то:	CHAIR AND MEMBERS LONDON ADVISORY COMMITTEE ON HERITAGE MEETING ON WEDNESDAY JULY 10, 2013	
FROM:	JOHN M. FLEMING MANAGING DIRECTOR, PLANNING AND CITY PLANNER	
SUBJECT:	HERITAGE ALTERATION APPLICATION BY: R. C. LEACH 366 CENTRAL AVENUE

#### Nature of the Application

368 Central Window Sill Detail

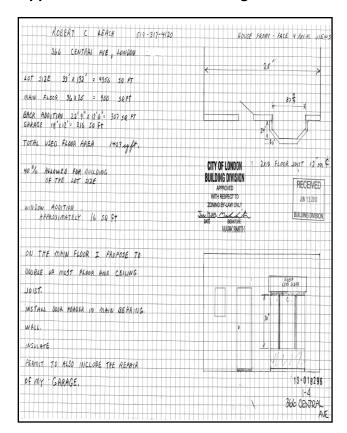
The alteration proposed for the main floor front window would change an architectural detail on the building, especially in comparison with its neighbour to the east. However, the impact of the change would not be highly visible from the street as it would be masked to an extent by the front porch rails and spindles and, possibly, even shrubs and bushes. The duplex at 368 has itself been altered somewhat with the creation of a second front door to access a second unit so the symmetry is no longer as strong. It is recommended that this alteration be approved on the condition that the style of window be consistent with the bay window on the second storey.

That, on the recommendation of the Director of Land Use Planning and City Planner, with the advice of the Heritage Planner, the Heritage Alteration Application of R. Leach requesting permission for an alteration to the main floor window **BE APPROVED**; and that an application to add a second dormer to the designated heritage property located at 366 Central Avenue **BE DENIED**; it being noted that the Heritage Planner has reviewed the proposed changes to the window opening and the roofline and has advised that the impact of such alteration on the heritage features of the property identified in the reasons for designation is negligible with respect to the window alteration but more significant with respect to the addition of a dormer. It should be further noted that the London Advisory Committee on Heritage has been consulted on these matters.
